STAFF REPORT
WEST ALLIS PLAN COMMISSION
Wednesday, January 26, 2022
6:00 PM
City Hall – Room 128

3. **Site, Landscaping, and Architectural Plans for a proposed professional office use to be located at 11548 W. Theo Trecker Way, submitted by Mark A. Molinaro Jr. (Tax Key 414-9992-017)**

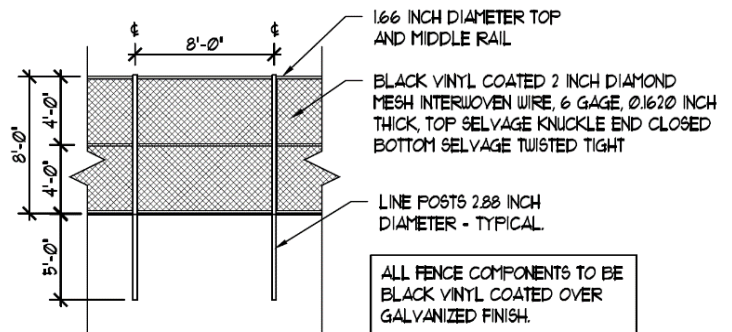
New fencing - The site plan, sheet A1.1 (below), indicates the proposed location of the fence to secure the vehicle parking and employee access to the building. The applicant proposes an 8-ft tall fence with privacy slats. A automated gated vehicle ingress/egress will be incorporated on the NW side of the fenced perimeter. In driving through the area, which is zoned light industrial, it is important to note that a fence of this height and material will not be out of ordinary.

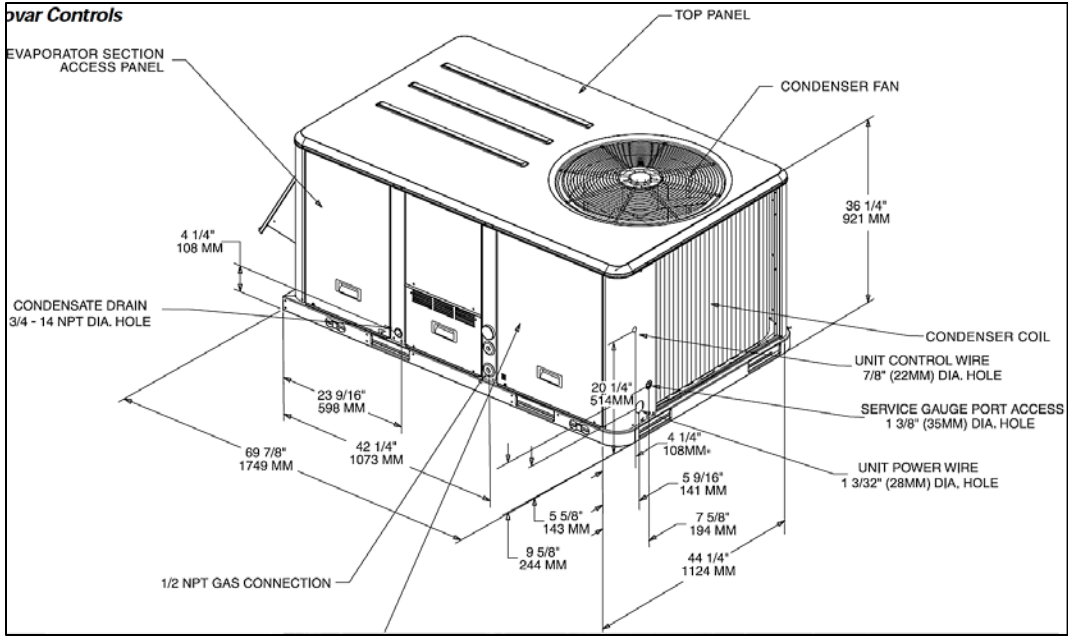
Roof top units (RTU) - The aerial image shows the existing building (birds eye view looking south toward W. Theo Trecker Way) and visual location of the existing roof top units.

The applicant will be removing 16 units on the north end of the building and replacing them with five new units (size specification on next page). In addition to having fewer units, only two of them will be on the Theo Trecker side of the roof and no closer to the west roof edge than the existing units. The new unit size is comparable to the size of the existing RTU.

Based on our review of the proposed changes, we do not believe roof screening will be required based on the unit positions, size and potential visibility of the units.
